ADDENDUM NO. 2

April 4, 2025

WCS Office Training Facility
2764 Commerce Rd
Wilson, NC 27893

B-1A

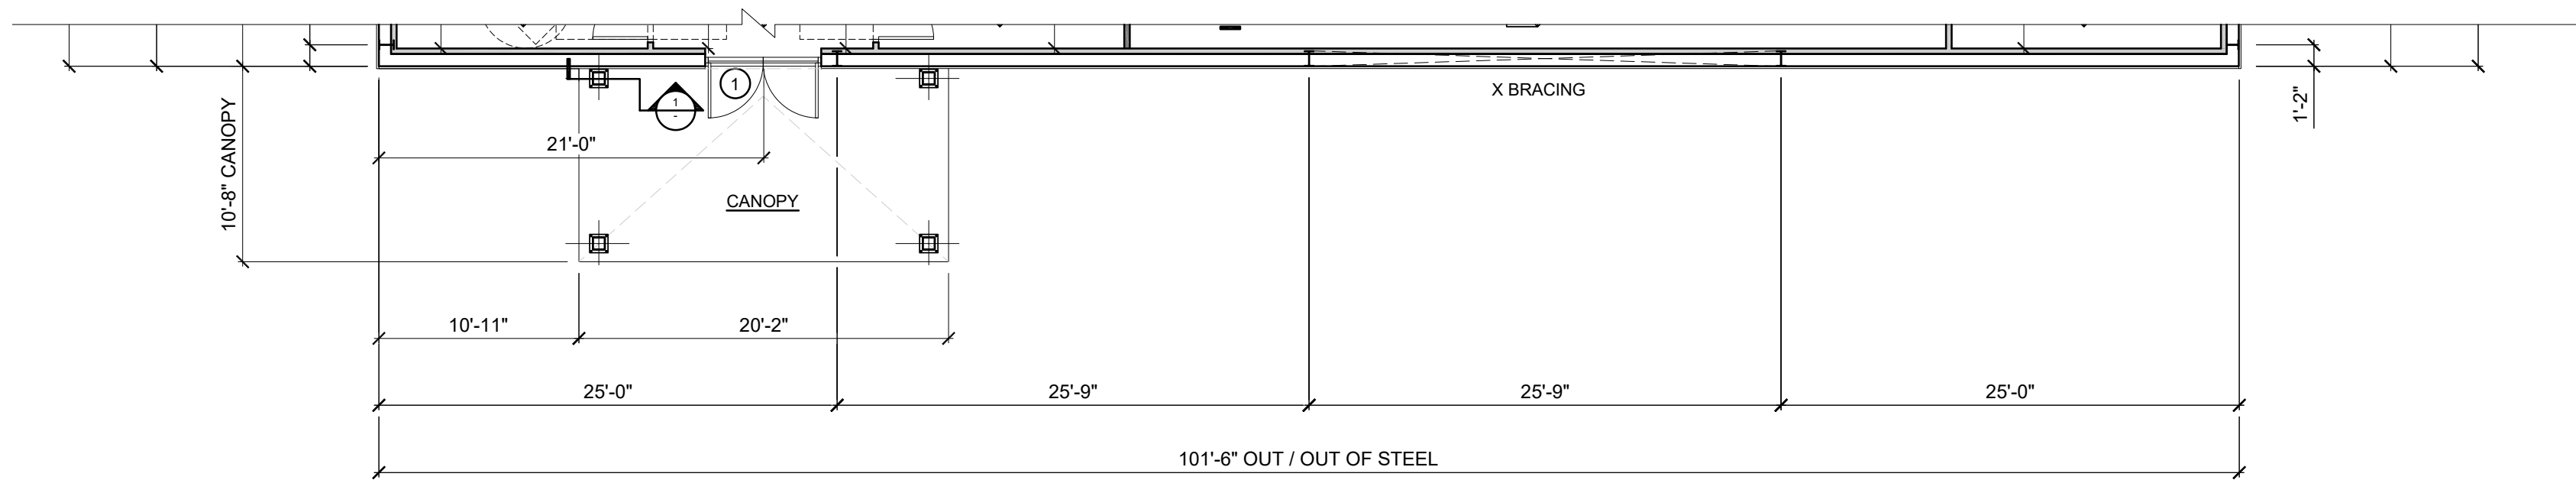
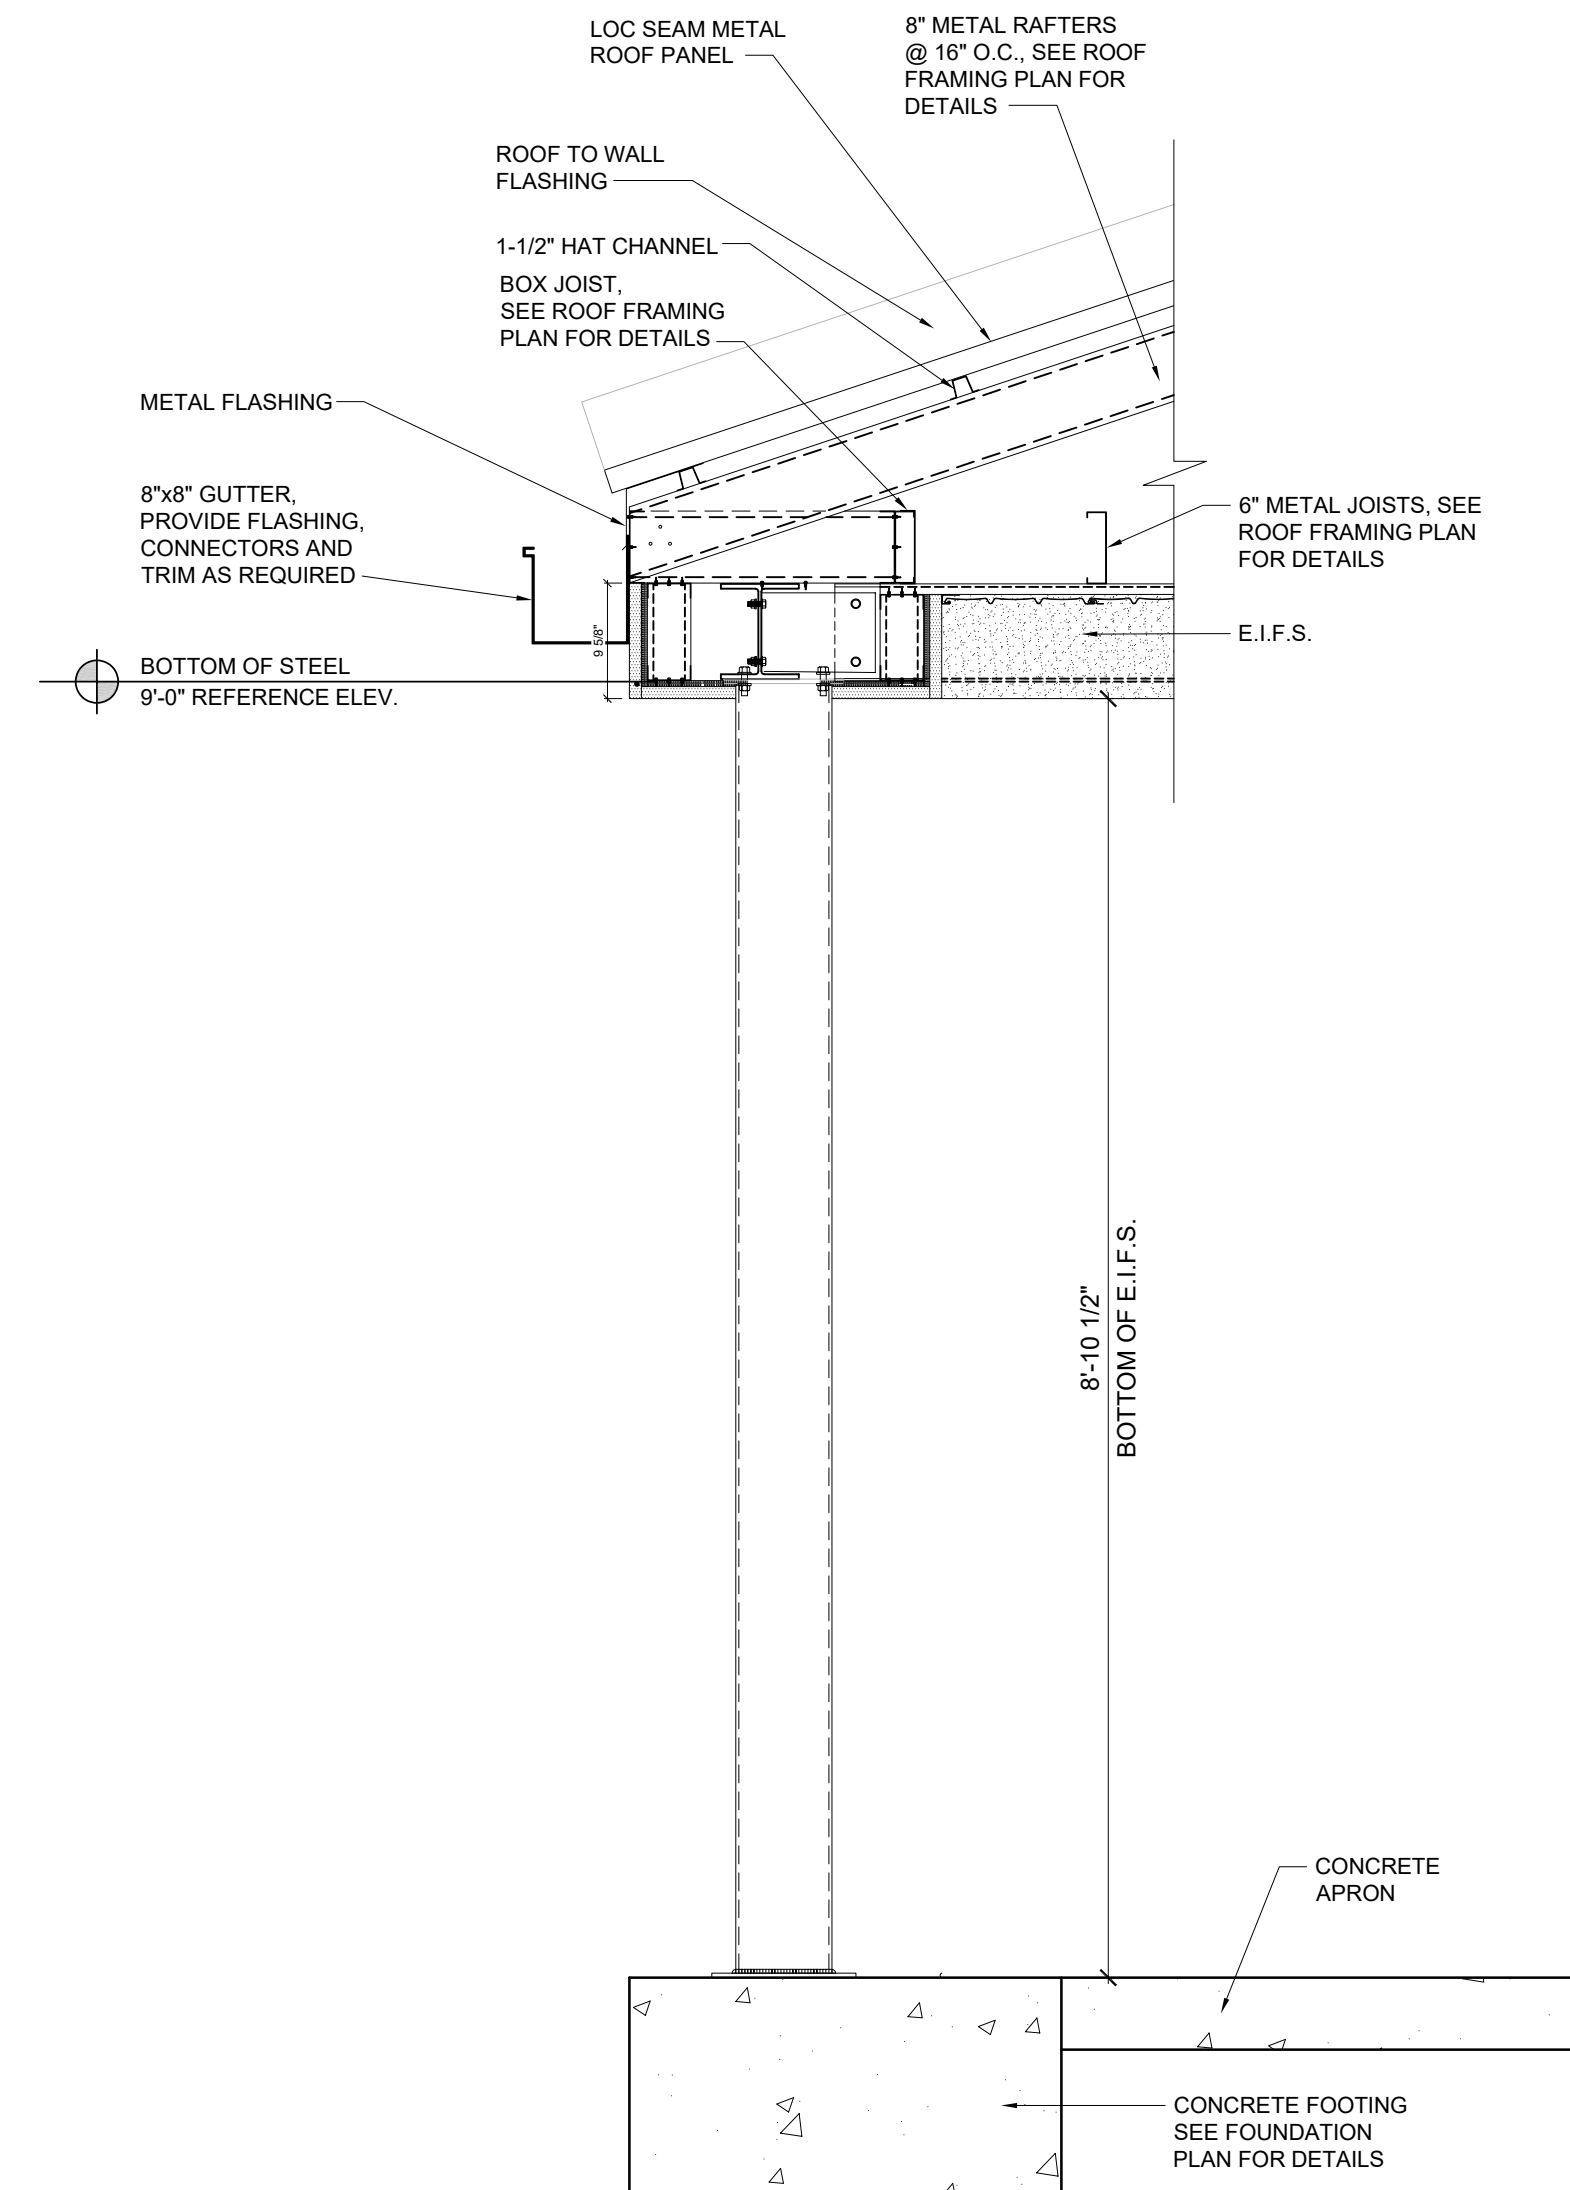
- A. Alternate No. 1: Outdoor Gun Range Improvements as per SP6
- B. Alternate No. 2: Water Search & Rescue Training Access Improvements as per SP6A
- C. Alternate No. 3: Floating Aerator/Fountain
- D. Alternate No. 4: Deduct to modify building façade to remove all brick from façade and keep metal, refer to B-1A

PLUMBING ACCESSORIES

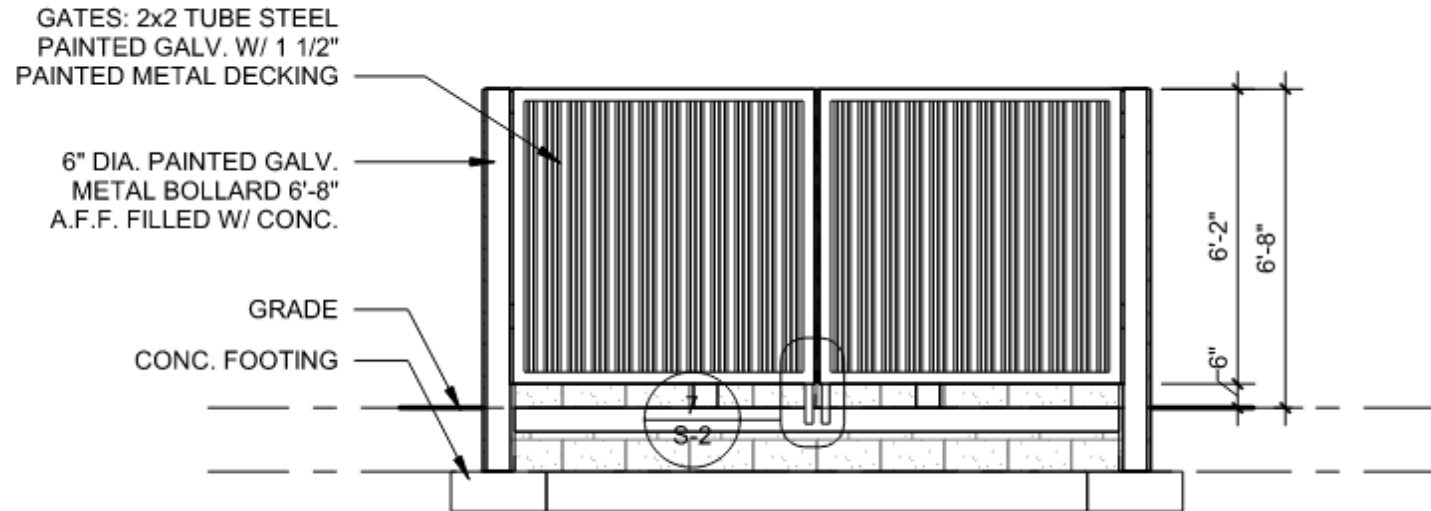
10	Will owner provide testing or do we as GC have to provide? If by GC, what testing is required? Thanks	Owner will contract testing through third party, GC to coordinate.
11	Spec for plumbing accessories on plan: FCO FLOOR CLEANOUT COAG EXTERIOR CLEANOUT WCO WALL CLEANOUT FD FLOOR DRAIN IMB ICE MAKER BOX HB INTERIOR HOSE BIB NFHB FROSTPROOF HOSE BIB	See attached "Plumbing Assessories"
12	Is the prebid meeting mandatory?	No, it is not mandatory.
13	In reviewing the plans for the Wilson County Sheriff's Office, both the Architectural & Structural notes call for CMU with "Grout Filled Cells". I just wanted to be sure that the intent is too have all of the CMU Grouted Solid – as there would be a substantial cost difference if Grout is only required at the Rebar Cells only.	All CMU to be grouted solid
14	Is Vulcan Steel Structures an approved vendor?	Yes
15	Who is responsible for permit fees?	GC is responsible for permit fees.
